Item Name: Crosstube Turning Detail

| DART AEROSPACE LTD | | Work Order: | 89480 |

| DRAWING NO. D212-664-147 | TITLE CROSSTUBE ASS'Y (205 LOW FWD) | REV. B | DART AEROSPACE LTD ENGINEERING ORDER | | D.E.O. NO. D212-664-147-B-1 | SHEET NO. SHEET 1 OF 1 | SCALE NTS |

PURPOSE:

**D212-664-147/-147B
ASSEMBLY DETAIL**

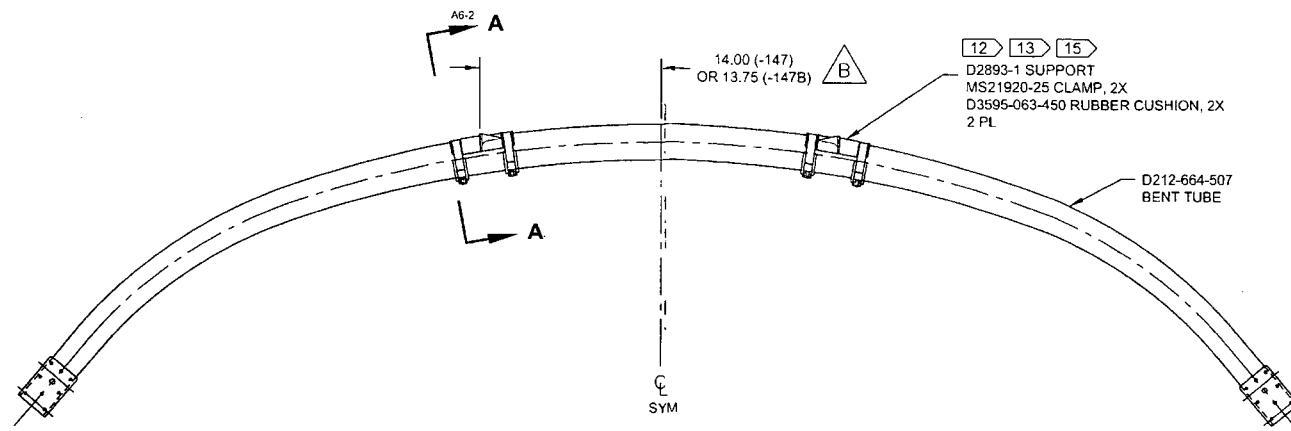
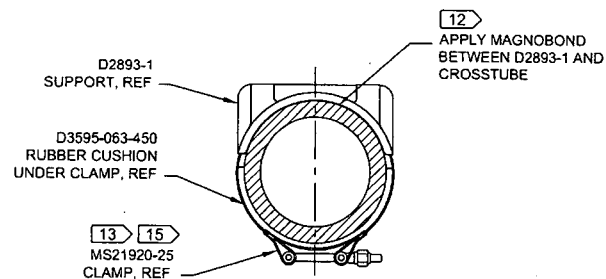
REPLACE MAGNOBOND WITH PROSEAL.

IS:

| Item | Qty -147 | Qty -147B | Part Number | Description |
|------|-------------|--------------|-----------------|-------------------------------|
| 9 | A/R | A/R | PROSEAL 890 B-2 | SEALANT, AMS-S-8802 CLASS B-2 |

WAS:

| 9 | A/R | A/R | MAGNOBOND 6398 | ROCKWELL SPECIFICATION RBO-120-023 ADHESIVE (TEXTRON/BELL SPEC. 299-947-100, TYPE II, CLASS 2 ADHESIVE) |

NOTE 12 & 15, SHEET 1 IS AMENDED AS FOLLOWS:

- 12) TO INSTALL D2893-1 SUPPORT: ABRASE MATING SURFACE OF SUPPORT AND CROSSTUBE WITH 180-GRIT SANDPAPER AND REMOVE RESIDUE WITH MEK (OR EQUIVALENT). APPLY A 0.04" TO 0.07" THICK LAYER OF PROSEAL 890 CLASS B-2 (OR AMS-S-8802 CLASS B-2) SEALANT TO MATING SURFACE OF SUPPORT.
- 15) TORQUE CLAMPS 80 TO 100 IN-LB. ENSURE AT LEAST 1.5 THREADS SHOWING IN SAFETY AND THAT NUT HAS NOT BOTTOMED-OUT AFTER TORQUING. **PRIOR TO PACKAGING, RE-CHECK TORQUE ON CLAMPS AFTER PROSEAL 890 SEALANT HAS CURED FOR 72 HOURS.**
